IEEE P802.15 Wireless Personal Area Networks

Project	IEEE P802.15 Working Group for Wireless Personal Area Networks (WPANs)	
Title	TG3 SB1 text for various resolution	
Date Submitted	[8 February, 2003]	
Source	[James P. K. Gilb] [Apparent Technologies] [15373 Innovation Drive, #210, San Diego, CA 92129]	Voice: [858-485-6401] Fax: [858-485-6406] E-mail: [gilb@ieee.org]
Re:	[]	
Abstract	[This document is a summary of some of the more complex comment resolutions for SB1.]	
Purpose	[To provide a concise summary of comment resolutions that are too complex to represent in the comment database.]	
Notice	This document has been prepared to assist the IEEE P802.15. It is offered as a basis for discussion and is not binding on the contributing individual(s) or organization(s). The material in this document is subject to change in form and content after further study. The contributor(s) reserve(s) the right to add, amend or withdraw material contained herein.

1 **1. Text for selected resolutions**

29
30
31
32
33
34
35
36
37
38
39
40 **Figure 1—PNC sending the piconet services command to a newly associated DEV in**
41 **response to a request in the association proces.**

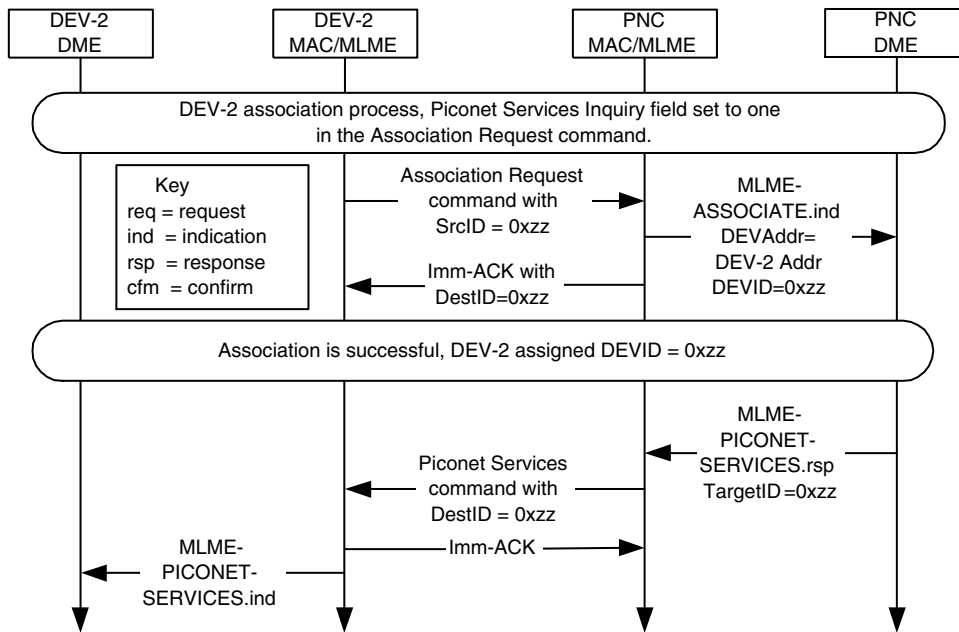
8
9 Accept in principle “Change to ‘If the DEV sets the piconet services inquiry bit, the PNC shall send the
10 piconet services command, 7.5.4.6, with DestID set to newly assigned DEVID after that PNC has received
11 the second Association Request command from the DEV, {xref }. This process is illustrated in {figure xx},’
12 and add new MSC as shown in 03/032r10.”
13
14
15
16
17
18

Figure 3—MSC for the handing over control of a private, pseudo-static CTA

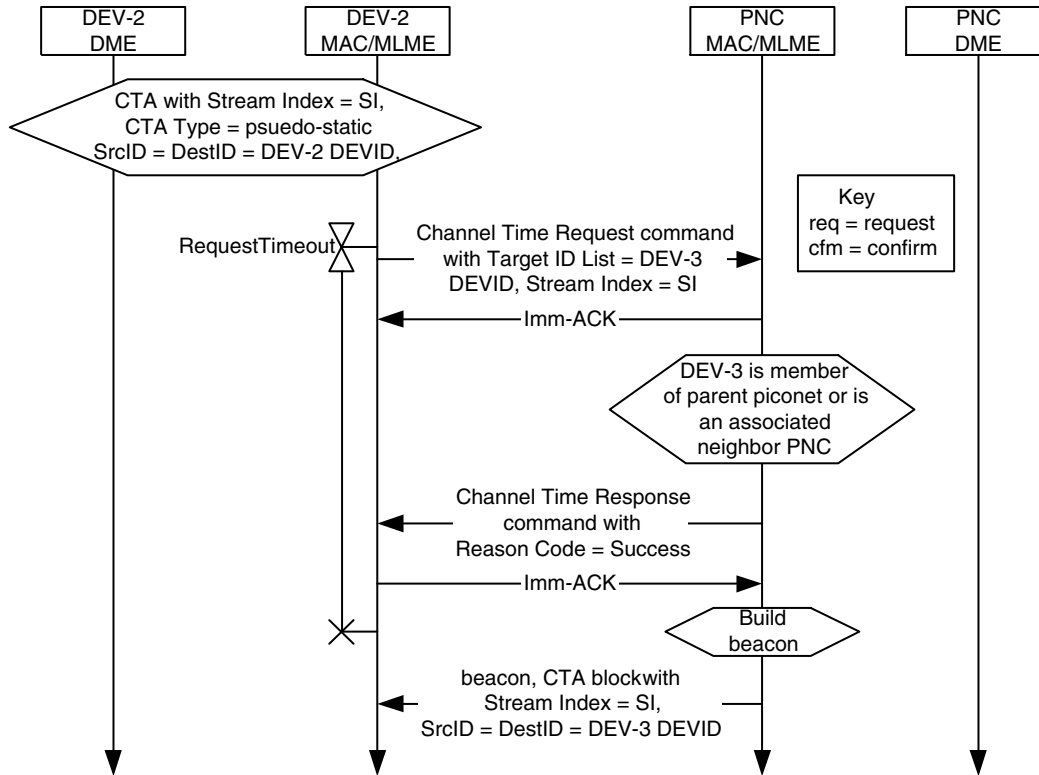
A dependent PNC, the originator DEV, may handover control of the dependent piconet's CTA to another DEV, the target DEV, in the parent piconet. The target DEV shall either be a member of the piconet or a DEV that has associated as a neighbor PNC, {xref association}. To handover control of the dependent piconet's CTA, the originator DEV shall send a Channel Time Request command to the parent PNC with the following parameters:

The MSC for the handover of the control of a private, pseudo-static CTA is illustrated in Figure 3.

Figure 4—Successful PNC handover in a dependent piconet.

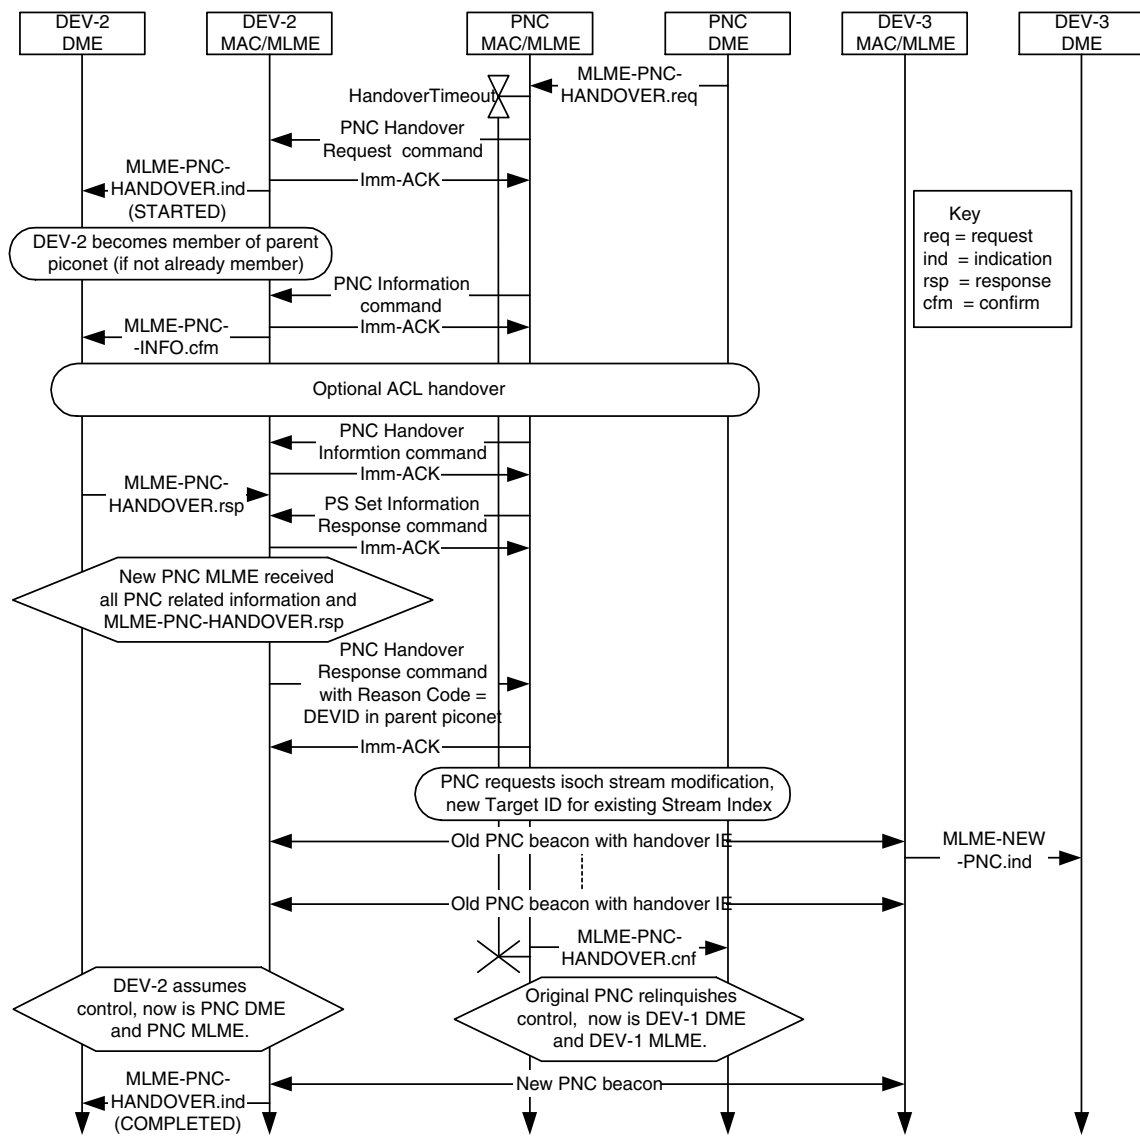
The dependent PNC handover process begins in the same manner as a regular PNC handover, {xref 8.2.3}, with the current PNC sending the PNC Handover Request Command to the target DEV that it has selected to

become the new PNC, as shown in Figure 4. In this and the two subsequent figures, the identities PNC, DEV-2 and DEV-3 are all relative to the dependent piconet and not the parent piconet. If the target DEV is not a member of the parent piconet, then that DEV shall begin the association process to join the parent piconet and, if required, authenticate with the parent PNC. The target DEV may request to associate with the parent piconet as either a neighbor PNC or as a member of the piconet. While target DEV is attempting to join the parent piconet, the current dependent PNC shall send the target DEV the information about all of the DEVs with the PNC Information command, all of the current channel time requests with the PNC Handover Information command and the power save information, if any, using the PS Set Information Response command. The target DEV may also request the transfer of any ACL data at this point using the ACL Information Request command. Note that the transfer of this information will not interfere with the target DEV's association and authentication process because the former occurs only during time reserved for the dependent piconet while the latter only occurs during time reserved for the parent piconet.

Figure 5—Failed dependent PNC handover when target DEV fails to join parent piconet.

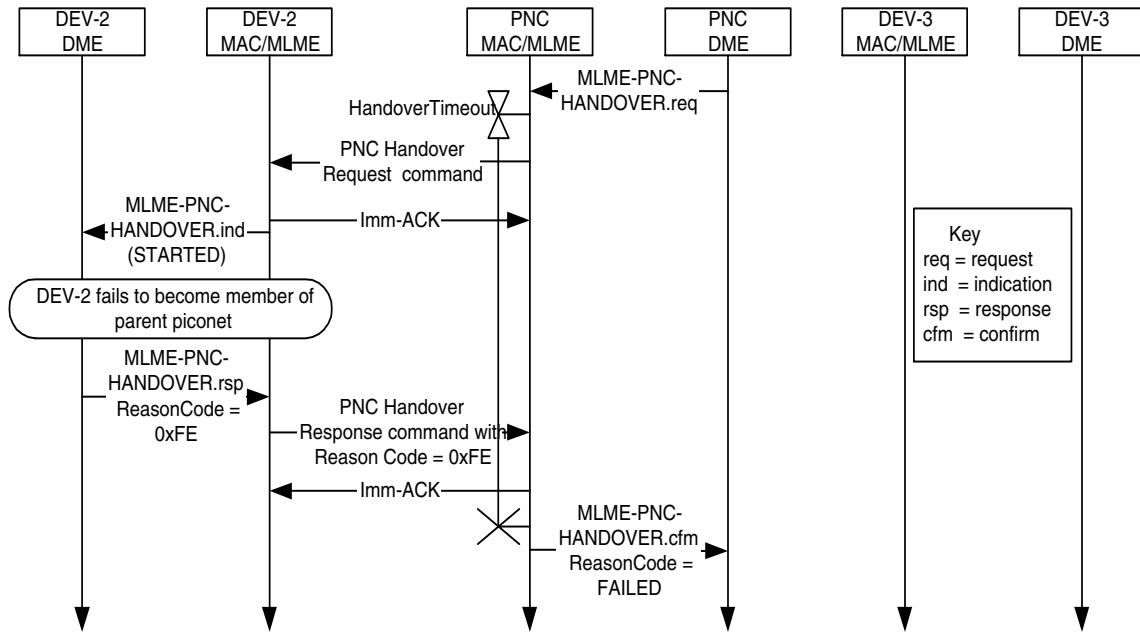
If the target DEV fails to join the parent piconet as either a regular DEV or as a neighbor PNC, it shall send the PNC Handover Response command to the dependent PNC with the Reason Code set to 'Handover

refused, unable to join parent piconet' as illustrated in Figure 5. The target DEV may refuse the handover at any time while the dependent PNC is sending over the information about the piconet.

Figure 6—Failed dependent PNC handover when control for the dependent piconet CTA is handed over in the parent piconet.

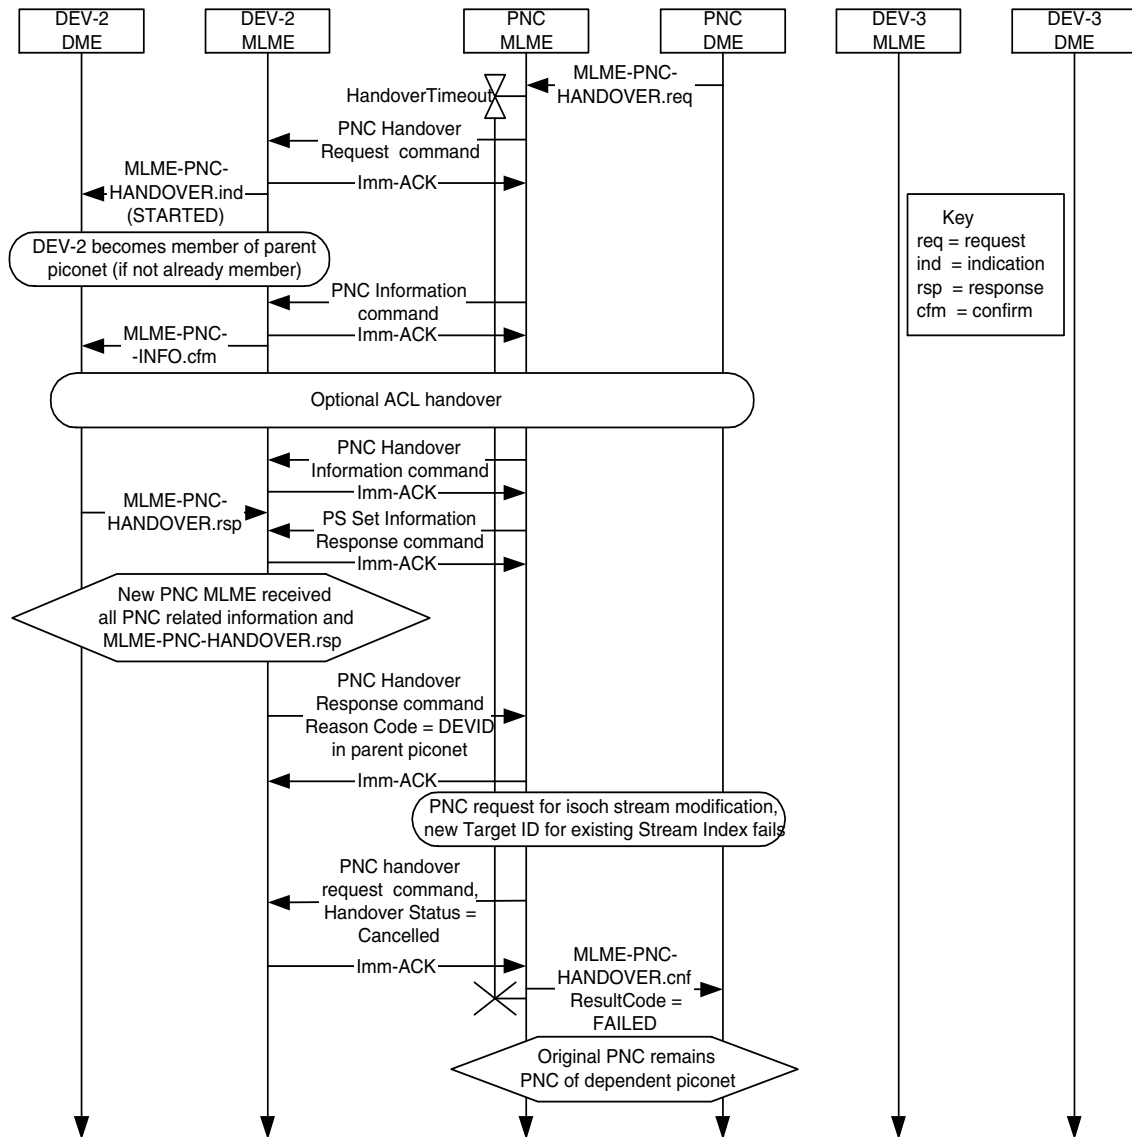
If the parent PNC rejects the request to handover control of the CTA to the new dependent PNC, the dependent PNC shall send a PNC Handover Request command to the target DEV with the Handover Status field set to 1 to indicate that the handover process is being cancelled, as illustrated in Figure 6.

Figure 7—Channel time request for frames with immediate ACKs

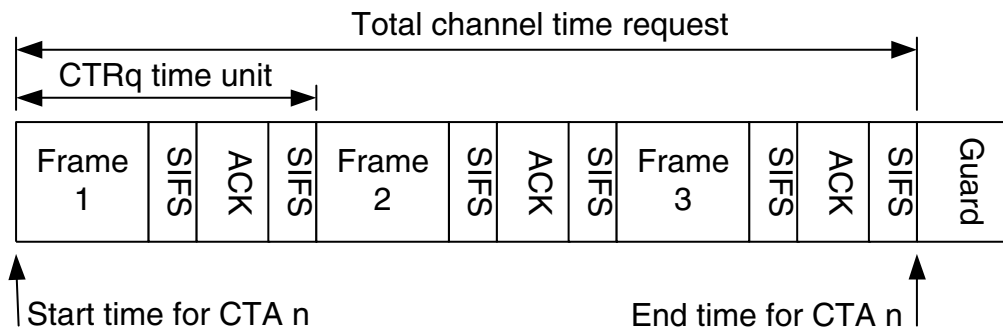
The requesting DEV shall include the frame transmission time, if known *a priori*, and the ACK transmission time, if used, and MIFS or SIFS time as appropriate per frame or ACK when calculating channel time requests. Figure 7 (was #108) shows an example of channel time being requested for a CTA where Imm-ACKs are used.

Figure 8—Channel time request with no ACKs

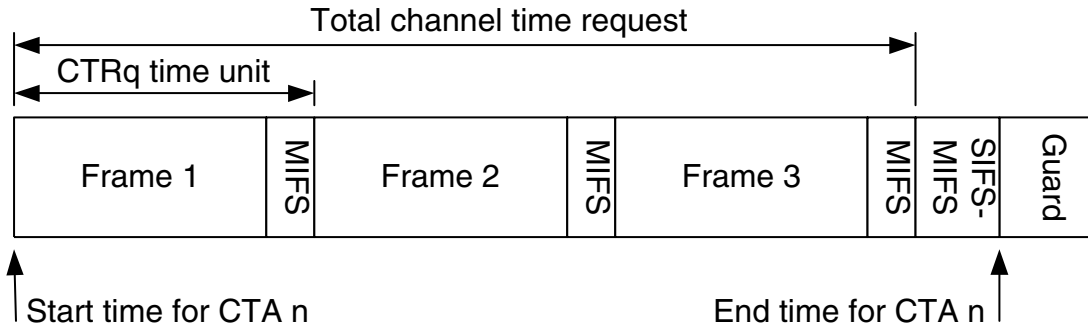
When No-ACK is used, the channel time request is calculated differently because there is a MIFS in between each frame in the CTA instead of a SIFS. A channel time request that uses a CTRq TU with MIFS instead of SIFS shall set the CTRq TU MIFS bit to one to inform the PNC that it must add a time equal to SIFS-MIFS to the end of the CTA. This ensures that there is a SIFS between the end of transmission in one CTA and the

start of the next. Figure 8 shows an example of a channel time request when no-ACK is used and the MIFS bit is set in the Channel Time Request command.

Figure 9—CTRq time unit covering multiple frames with CTRq TU MIFS = 0

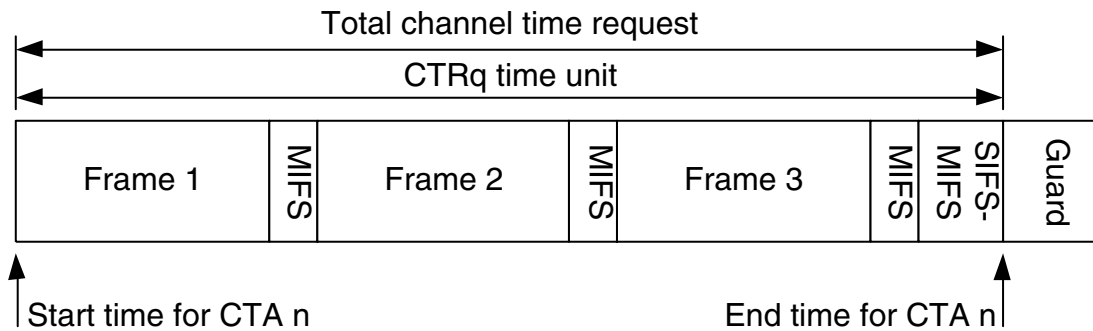
A CTRq TU in the CTA may cover more than one frame as shown in Figure 9. If the requesting DEV included SIFS-MIFS following the last MIFS as shown in Figure 9 it shall set the CTRq TU MIFS in the Channel Time Request to “0.” IF SIFS-MIFS is not included in the CTRq TU, the CTRq TU MIFS bit shall be set to “1” and the PNC shall add SIFS-MIFS to the CTRq TU to calculate the duration of the CTA. Figure 9 shows a multi-frame CTRq with the CTRq TU MIFS field set to 0.

Figure 10—CTRq time unit covering multiple frames with CTRq TU MIFS = 1

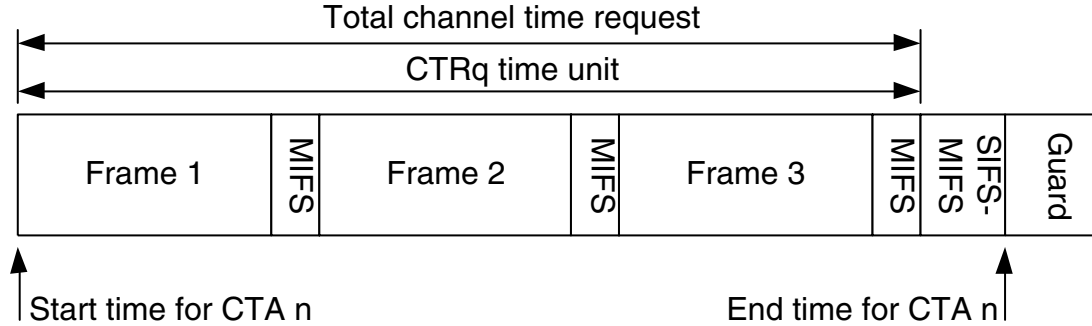
Figure 10 shows a multi-frame CTRq with the CTRq TU MIFS field set to 1.
